Application/Control Number: 10/580,584 Page 2

## **DETAILED ACTION**

4. Claims 1, 4, 12, 14, 15, and 17 are rejected under 35 U.S.C. 103(a) as being unpatentable over Vailliencourt et al. (5,341,946) [Vailliencourt] in view of Itaba et al. (5,227,233) [Itaba].

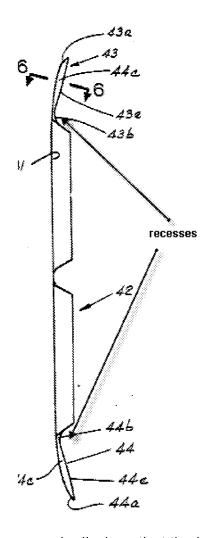
Regarding Amended Claim 1 and Claim 17, the patent to Vailliencourt – a hot-filled plastic container with label – discloses a synthetic resin container [Fig. 1] comprising a container body of a first material made of PET [10, Col. 4 Lines 47-49], said container body having a main portion formed with a plurality of sectioned recesses [32a, 43b, 44b], said container further comprising: a label [23] arranged at said main body portion of the container body and surrounding the main body portion [Fig. 1], wherein the label is immovably arranged on the main body portion through an adhesive layer [Col. 5 Lines 15-17].

Regarding Claim 12, Vailliencourt in view of Itaba discloses all the limitations substantially as claimed, as applied to amended claim 1 above; further, Vailliencourt discloses closed air layers [Vailliencourt, 32a] provided between the plurality of sectioned recesses and the label [Vailliencourt, Fig. 4].

Regarding Claim 14, Vailliencourt in view of Itaba discloses all the limitations substantially as claimed, as applied to amended claim 1 above; further, Vailliencourt discloses the container has a longitudinal axis [Vailliencourt, Fig. 1] and the label is adhered at upper and lower end regions of the label along the longitudinal axis [Vailliencourt, Col. 5 Lines 15-17].

portions [Vailliencourt, 32a] extending about the longitudinal axis on opposite sides of the plurality of sectioned recesses [Vailliencourt, 43b, 44b], the annular groove portions being covered by the label [Vailliencourt, 23, Fig. 1].
